Order this document by
MC68341UMAD/AD

MC68341

ADDENDUM TO MC68341 Integrated Processor User's Manual

April 19, 1995

Figure 3-12. M68300 Write Cycle timing

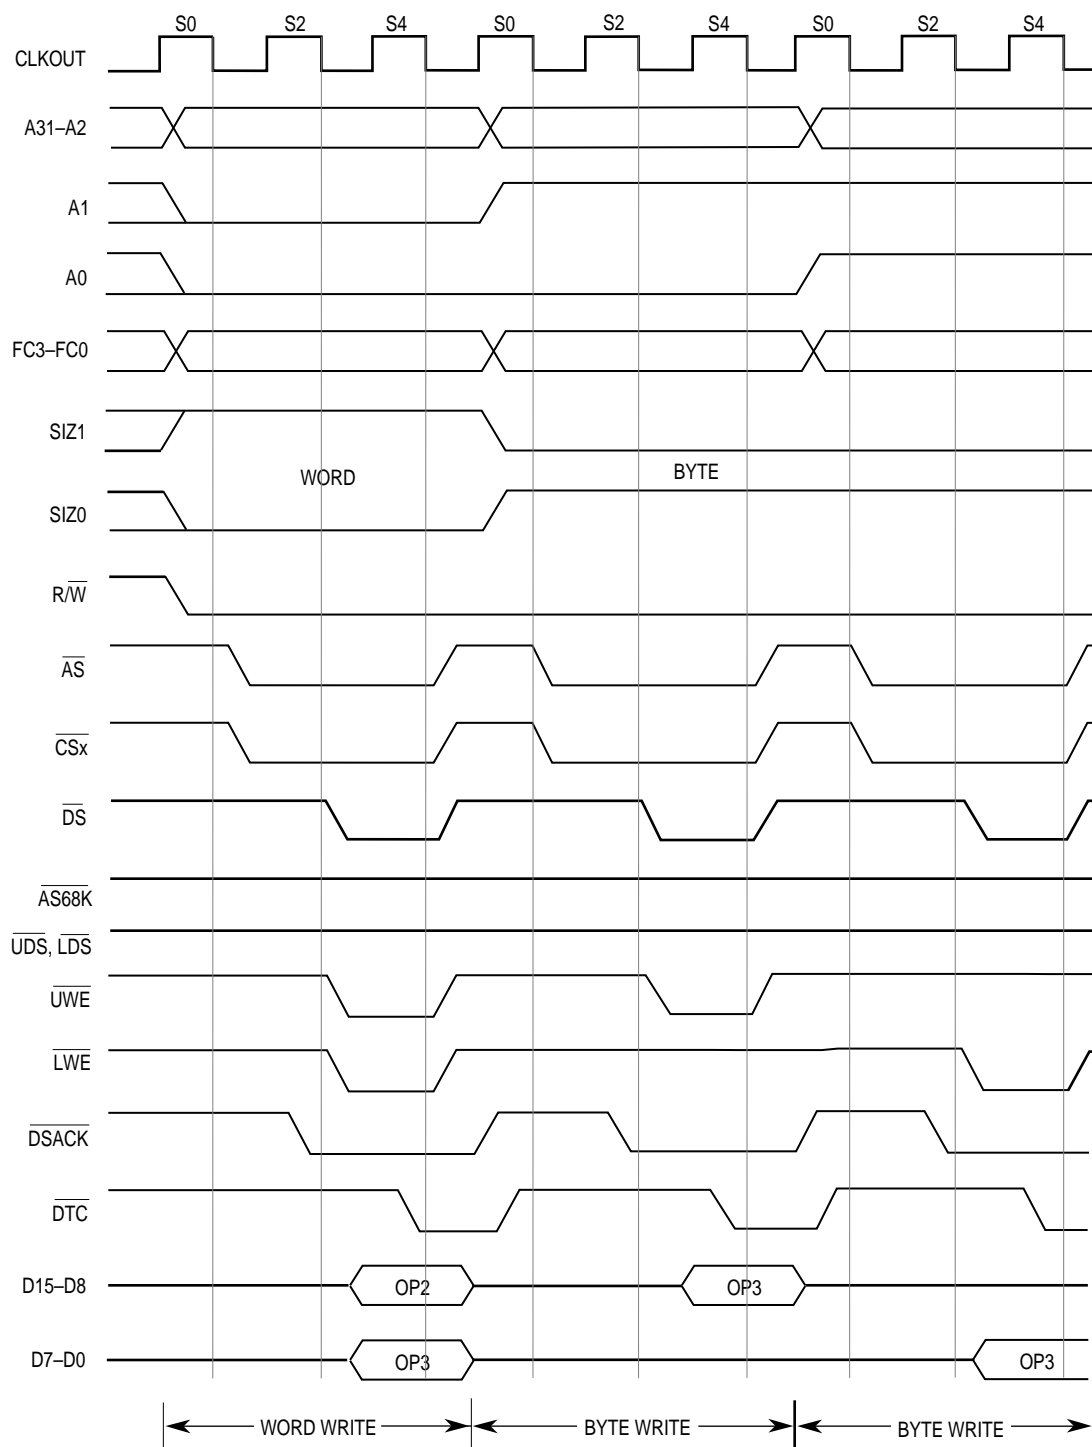
On page 3-25, the M68300 write cycle timing diagram (Figure 3-12) shows incorrect timing for \overline{DS} , \overline{UWE} , and \overline{LWE} . On page 3-28, the M68000 write cycle timing diagram (Figure 3-14) shows incorrect timing for $\overline{AS68K}$, \overline{CSx} , $\overline{UDS/LDS}$, and $\overline{UWE/LWE}$. Replace these figures with the following corrected figures.

Figure 11-2. Sample Crystal Circuit

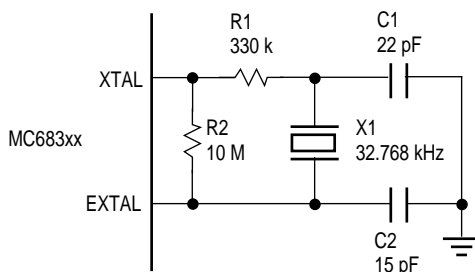
On page 11-2, Figure 11-2, a 10M resistor can be substituted for the 20M R2 bias resistor as shown below.

Figure 11-14. Circuit For Interfacing 8-Bit Device to 16-Bit Memory in Single-Address DMA Mode

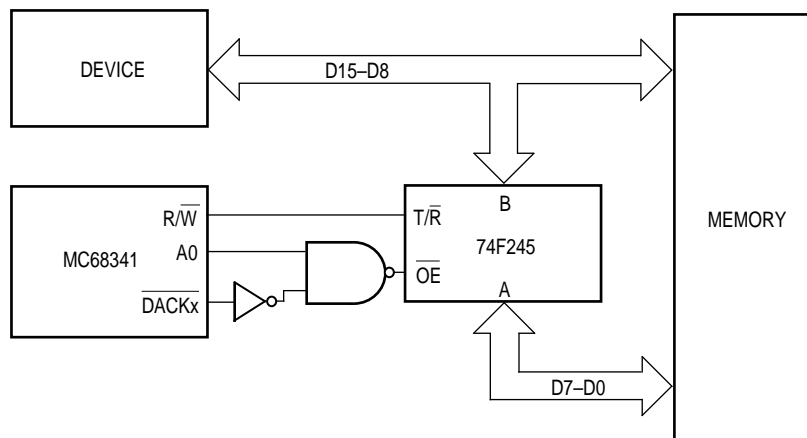
On page 11-10, the logic driving $\overline{\text{OE}}$ on the 74F245 in Figure 11-14 should be corrected as shown below. Although not detailed, the byte enables for the memory block should be controlled during reads to prevent contention between the upper and lower bytes of the data bus when D7-D0 is muxed to the upper data byte.

80. Page 9-19,

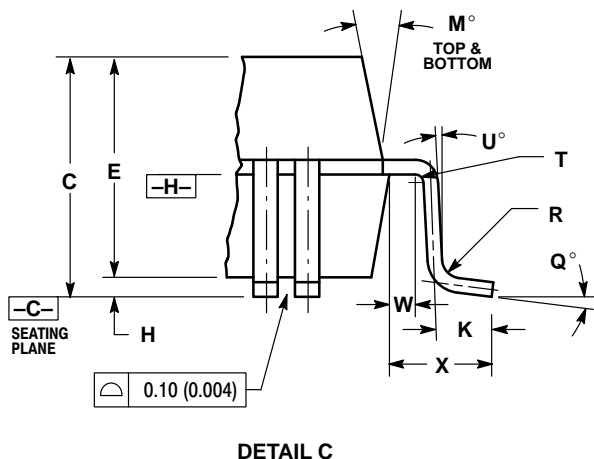
The timing diagrams reference as Figures 9-24 — 9-27 should be changes to 12-22–12-25.
